**Partial Response to
Request for Additional Information (RAI) - Dated April 17, 2002
Regarding High Burnup Fuel in Dry Storage**

B. Letter from Lynnette Hendricks (NEI) to E. William Brach (NRC), dated 10/02/01, transmitting report entitled "Creep Modeling and Analysis Methodology for Spent Fuel in Dry Storage"

Figure 1 – FALCON R-θ Grid for Local Effect Creep Analysis of Cladding with Zero-Strength Hydride Lens

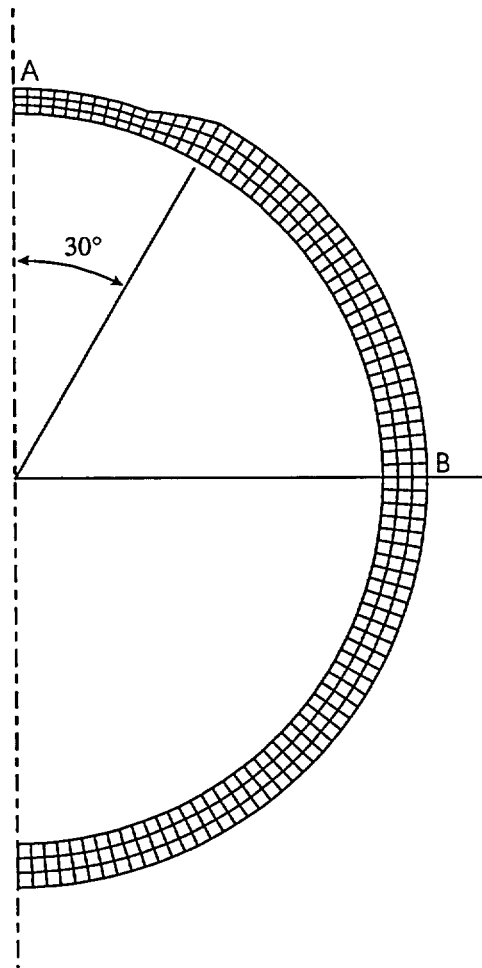
Question B.3: Please elaborate on the technical meaning and significance of peak strain, mentioned in Table 7, and its relevance for dry storage.

Response: The peak strain is the membrane (mid-wall) strain calculated at Point A in Figure 1, which simulates the presence of a zero-strength hydride lens. This point is the highest stress point in the cladding cross section, and consequently shows the highest strain. It has no special relevance to dry storage other than the fact it is the highest strain value in the cladding, and consequently shows the highest cumulative damage. It should be noted, however, that if such a condition exists in storage, this

“peak strain” evolves asymptotically with time and remains bounded, as shown in EPRI-1003135. In other words, the fact that the “peak strain” reflects a point of stress and strain concentration, it introduces no unusual change in the behavior of the cladding.

Figure 2 – Hoop Strain During Vacuum Drying Compared to the Constant-Temperature Case

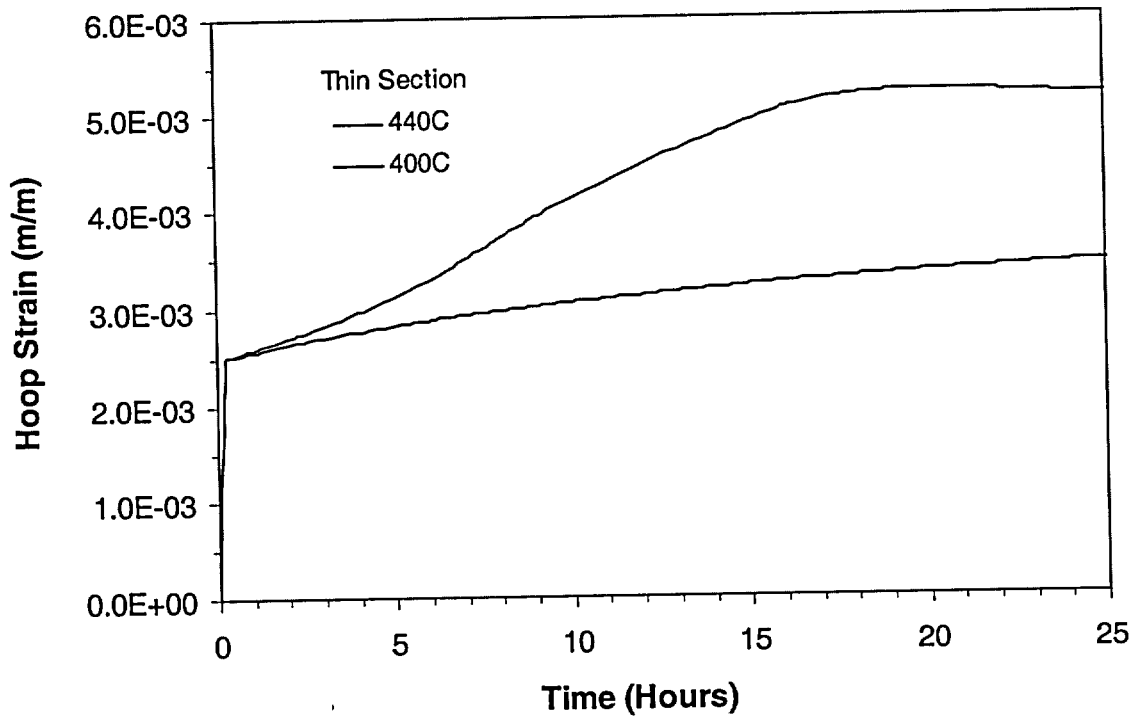
Question B.2: On page 29, it has been stated that a 40°C temperature rise during vacuum drying has been superimposed on all cases covered in Table 6. Clarify how the rate of change of temperature with time, $\Delta T/\Delta t$, during ramp up and ramp down was treated for creep calculations. Discuss the fractional contribution of the creep during this drying stage to the overall creep during dry storage.

Response: To illustrate the effect of the vacuum-drying cycle, we have selected Case-34 from the referenced table and carried out two creep analyses, with and without the drying cycle, for the cladding geometry shown in Figure 1. This figure depicts the cladding geometry used in EPRI-1003135, and is a simulation of the presence of a zero-strength hydride lens. The vacuum-drying cycle, which consisted of 8 hours ramp up from the initial temperature of 400°C, 8 hours hold at 440°C, and 8 hours ramp down to 400°C, was treated in the creep analysis as the initial part of the temperature history. The new calculations are depicted in Figure 2. This figure shows the hoop strain (elastic + creep) for Point A in Figure 1, for the first 24 hours of the history, which covers the vacuum drying cycle. Figure 3 shows the hoop stress history for the same time period. It should be noted, that the analysis was conducted for much longer period to see if there is a long-term decaying, or amplification, effect of the drying cycle, but the results, as expected, showed no such effect beyond 24 hours. Therefore, the results were plotted for the first 24 hours for better visualization.

As can be seen from Figure 2, the drying cycle causes an increase of less than 0.2% in the hoop strain, which is contributed by the faster creep rate due to both the temperature increase and the temperature-induced change in the pressure. The continuous rise in temperature and pressure during the first eight hours of the drying cycle induced the positive curvature that can be seen in the strain plot, showing an apparent acceleration of the creep rate similar to the tertiary regime. This is not a tertiary creep behavior, however, because the change in the creep rate is due to the change in the temperature and the applied stress, unlike classical tertiary creep, which evolves in response to wall thinning. The stress time histories are shown in Figure 3, which shows the effect of the temperature rise on the pressure for the vacuum-drying case.
